Vermont Agency of Transportation

SHOP DRAWING REVIEW	
<input type="checkbox"/> REVIEWED AS REQUIRED BY THE CONSTRUCTION CONTRACT DOCUMENTS AND APPROVED, BUT ONLY FOR CONFORMANCE TO THE DESIGN CONCEPT OF THE WORK, AND SUBJECT TO FURTHER LIMITATIONS AND REQUIREMENTS CONTAINED IN THE CONSTRUCTION CONTRACT DOCUMENTS.	
<input type="checkbox"/> REJECTED	<input type="checkbox"/> REVISE AND RESUBMIT
<input checked="" type="checkbox"/> FURNISH AS CORRECTED	
CORRECTIONS OR COMMENTS MADE ON THE SHOP DRAWINGS DURING THIS REVIEW DO NOT RELIEVE CONTRACTOR FROM COMPLIANCE WITH REQUIREMENTS OF THE DRAWINGS AND SPECIFICATIONS. THIS CHECK IS ONLY FOR REVIEW OF GENERAL CONFORMANCE WITH THE DESIGN CONCEPT OF THE PROJECT AND GENERAL COMPLIANCE WITH THE INFORMATION GIVEN IN THE CONTRACT DOCUMENTS. THE CONTRACTOR IS RESPONSIBLE FOR CONFIRMING AND CORRELATING ALL QUANTITIES AND DIMENSIONS; SELECTING FABRICATION PROCESSES AND TECHNIQUES OF CONSTRUCTION; COORDINATING HIS WORK WITH THAT OF ALL OTHER TRADES; AND PERFORMING HIS WORK IN A SAFE AND SATISFACTORY MANNER.

VHB	Job Number: 5745B
	Reviewed By: G.S. Goodrich
	Date: 6-27-14

F.R. LaFAYETTE
MIDDLEBURY
P/N: 0057.90012
MAT: ASTM A500 Gr. B
QTY: 1

WW1

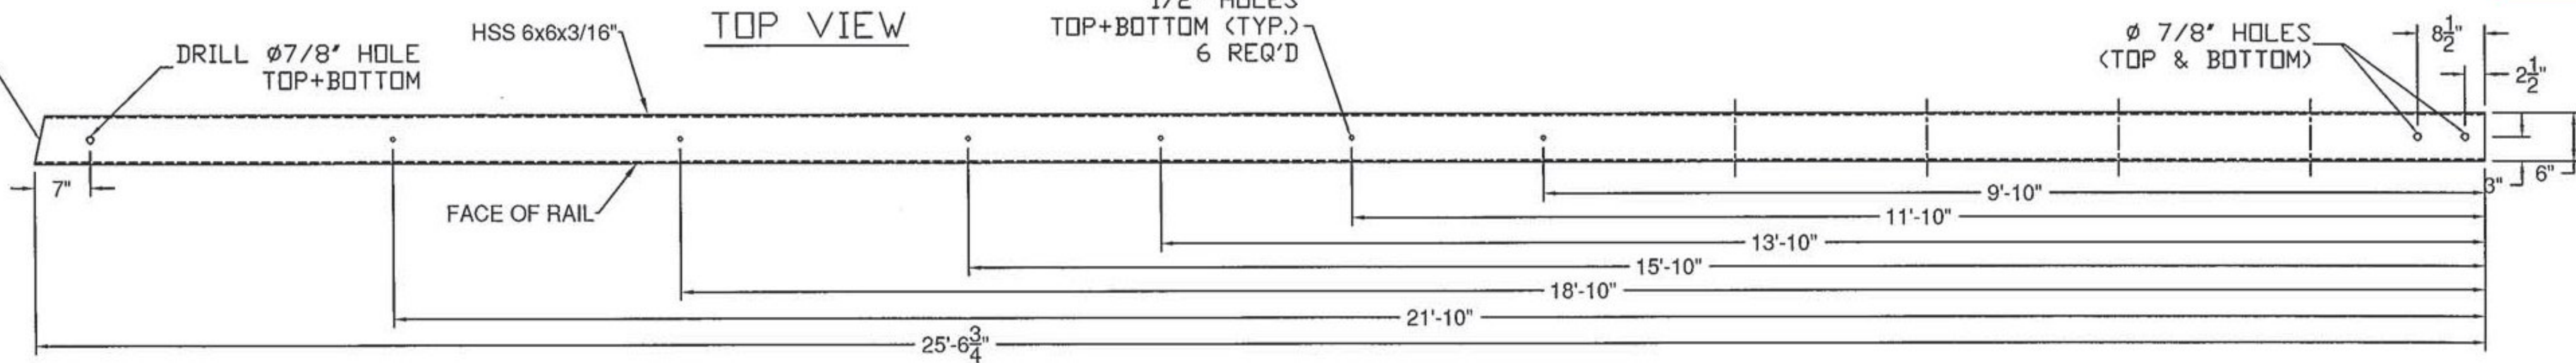
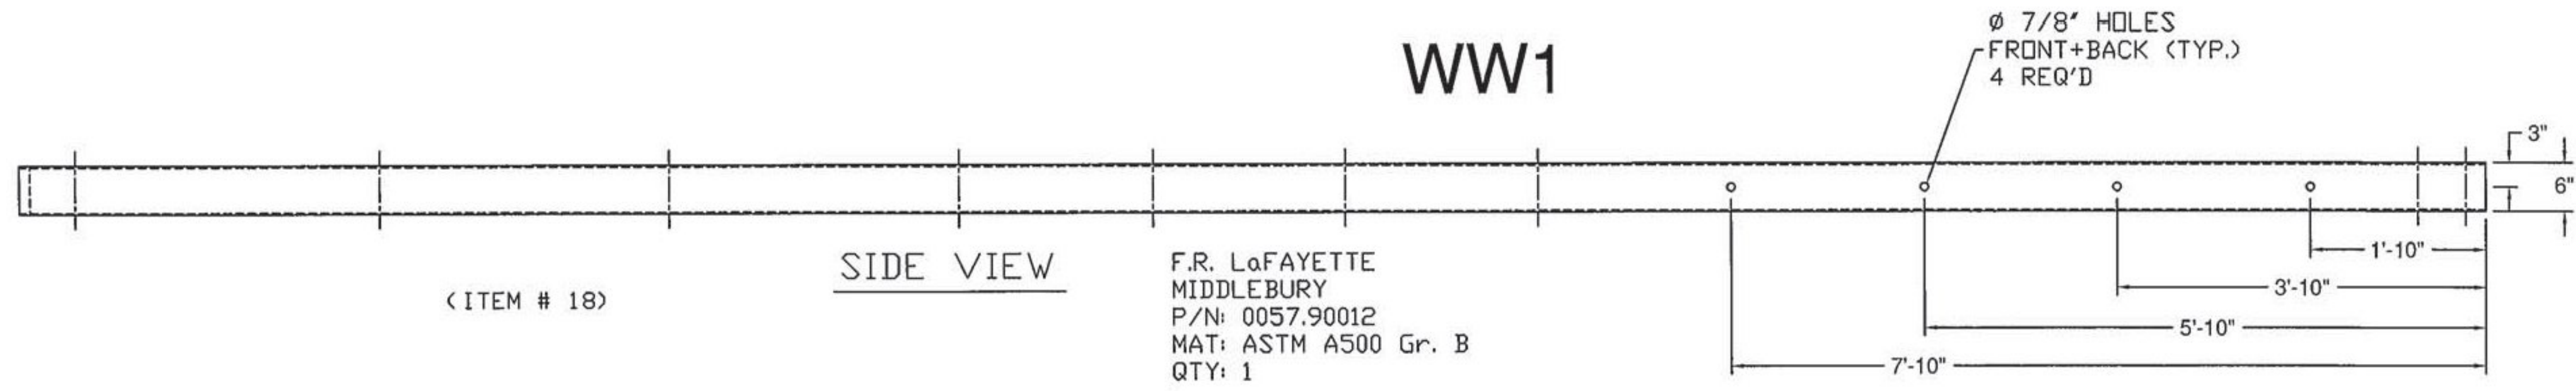
Per phone call with Eugene Peek of Elderlee, Inc. at 11:15 on 6/27/2014 (315)789-6670, the angle comment shown below corresponds to the Elderlee's detail as drawn. This angle matches the deflection angle required by design.

FACE OF RAIL TO HAVE
19'-6" CONVEX RADIUS

Angle 31.1803611 degrees.

MITER CUT FOR
9'-0" KICKBACKS
@ 21°
